Baby Vox Mod

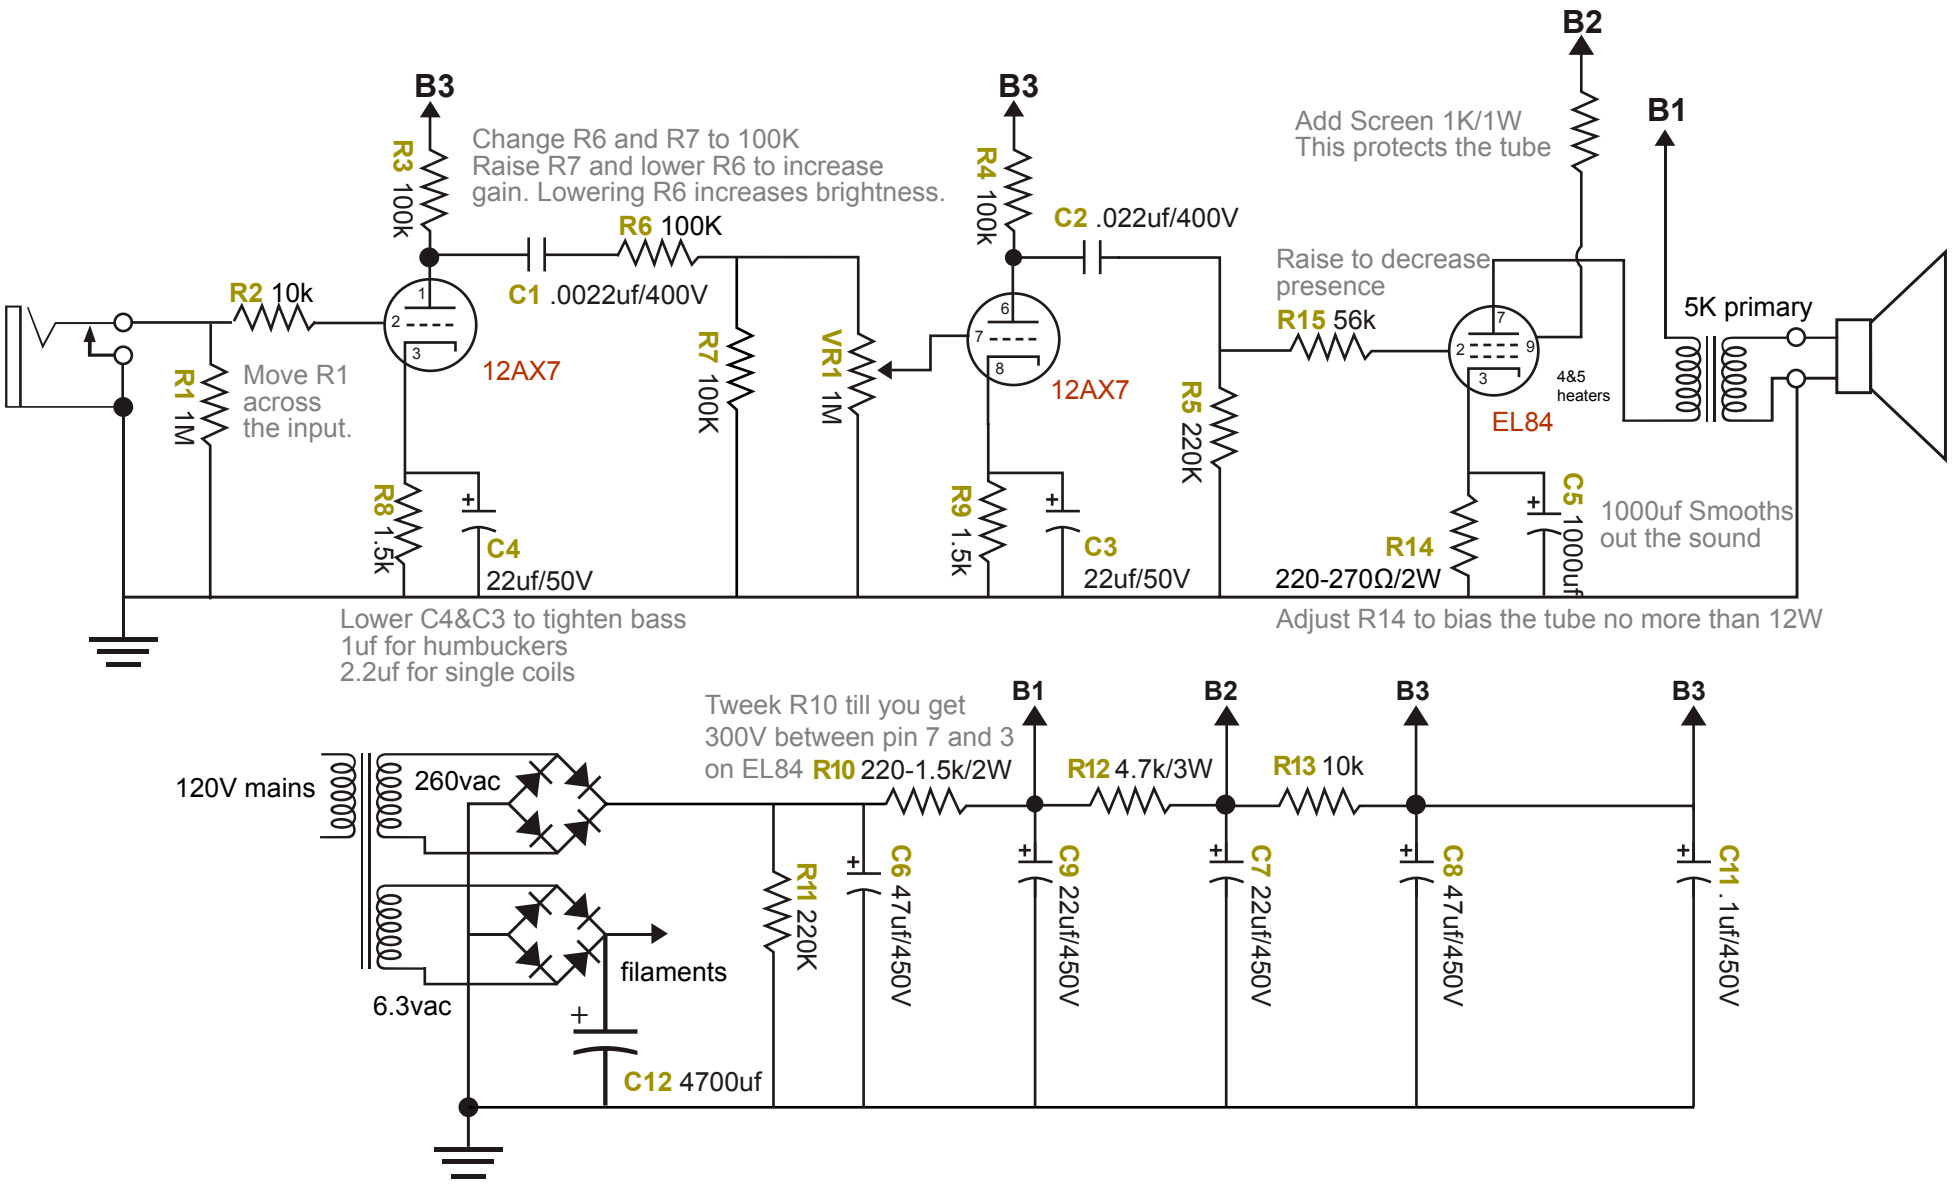
B3
R3 100k
Change R6 and R7 to 100K
Raise R7 and lower R6 to increase
gain. Lowering R6 increases brightness.
R6 100K
C1 .0022uf/400V
R2 10k
R1 1M
Move R1
across
the input.
12AX7
R7 100K
VR1 1M
R8 1.5k
C4
22uf/50V
B3
R4 100k
C2 .022uf/400V
12AX7
R9 1.5k
C3
22uf/50V
R5 220K
B2
Add Screen 1K/1W
This protects the tube
B1
Raise to decrease
presence
R15 56k
4&5
heaters
EL84
5K primary
R14
220-270Ω/2W
C5 1000uf
1000uf Smooths
out the sound
Lower C4&C3 to tighten bass
1uf for humbuckers
2.2uf for single coils
Adjust R14 to bias the tube no more than 12W
Tweek R10 till you get
300V between pin 7 and 3
on EL84 R10 220-1.5k/2W
B1
B2
B3
B3
R12 4.7k/3W
R13 10k
120V mains
260vac
6.3vac
filaments
C12 4700uf
R11 220K
C6 47uf/450V
C9 22uf/450V
C7 22uf/450V
C8 47uf/450V
C11 .1uf/450V
